**SUNDRY NOTICES AND REPORTS ON WELLS**  
**Do not use this form for proposals to drill or to re-enter an  
abandoned well. Use Form 3160-3 (APD) for such proposals.**

1. Type of Well <input checked="" type="checkbox"/> Oil Well <input type="checkbox"/> Gas Well <input type="checkbox"/> Other		7. If Unit of CA/Agreement, Name and/or No.
2. Name of Operator Vanguard Operating, LLC		8. Well Name and No. China Federal #1
3a. Address 5847 San Felipe St., Ste. 3000, Houston, TX 77057	3b. Phone No. (include area code)	9. API Well No. 30-005-60863
4. Location of Well (Footage, Sec., T., R., M., or Survey Description) 660' FNL & 1980' FEL UL B Sec 18 T07S R23E		10. Field and Pool or Exploratory Area Pecos Slope, ABO, West
		11. Country or Parish, State Chavez County New Mexico

**China Federal 1  
30-005-60863  
Vanguard Operating, LLC  
October 16, 2018  
Conditions of Approval**

AFTER P&A

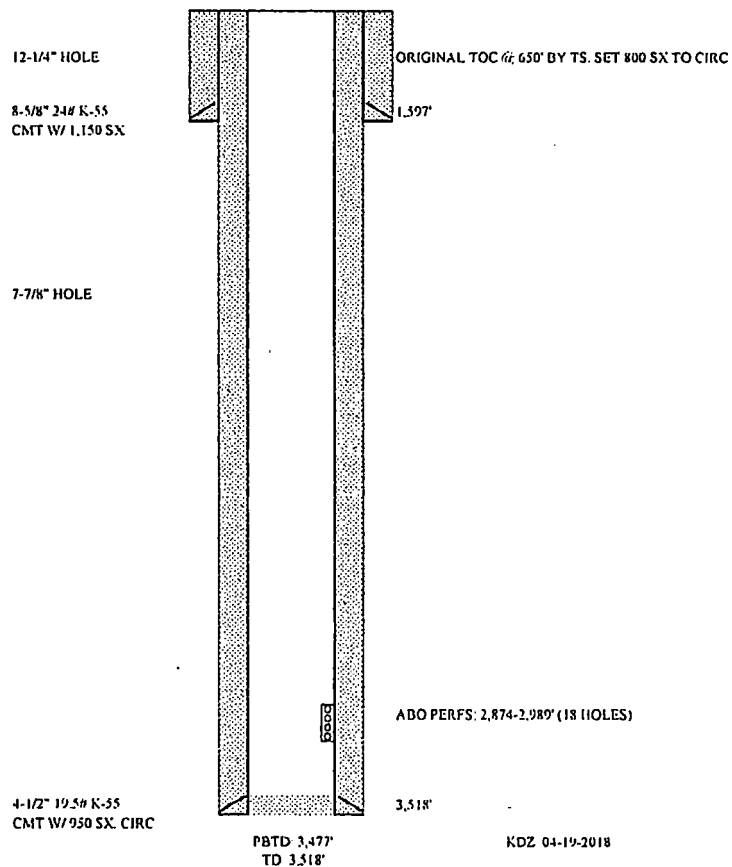
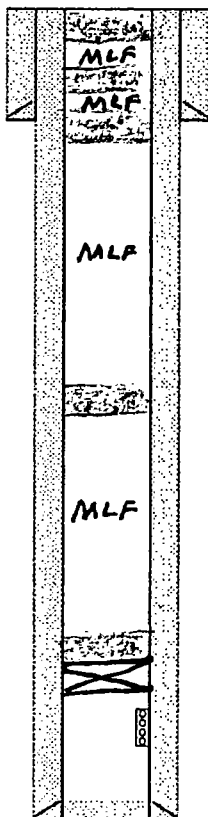
1. Notify BLM 24 hrs prior to MIRU to P&A.
2. Set CIBP @ 2824' RIH w/tbg & tag circ hole w/mud laden fluid & test csg spot <sup>25</sup> 20 sx's "c" cmt F/2824'-2724' WOC & tag if csg don't test.
3. Spot 20 sx's "c" cmt F/2200'-2100' (Tubb) spot 30 sx's "c" cmt F/1650'-1500' (8 5/8" Shoe) spot 40 sx's "c" cmt F/800'-550' (Yeso, Glorieta) WOC & tag.
4. Spot 20 sx's "c" cmt F/100'-surf.
5. RD P&A equip , cut off wellhead, install dry hole marker, clean location & move off.

- 1. Operator shall place CIBP 2,824' (50'-100' above top most perf) and place 25 sx of Class C cement on top to seal the Abo Formation. WOC and TAG.**
- 2. Operator shall place a Class C cement plug from 2,200'-2,100' as proposed. WOC and TAG.**
- 3. Operator shall place a Class C cement plug from 1,650'-1,500' as proposed to seal the 8-5/8" shoe. WOC and TAG.**
- 4. Operator shall place a Class C cement plug from 800'-550' as proposed to seal the Glorietta Formation. WOC and TAG.**
- 5. Operator shall perf and squeeze at 100'. Operator shall place a Class C cement plug from 100' to surface as proposed.**
- 6. See Attached for general plugging stipulations.**
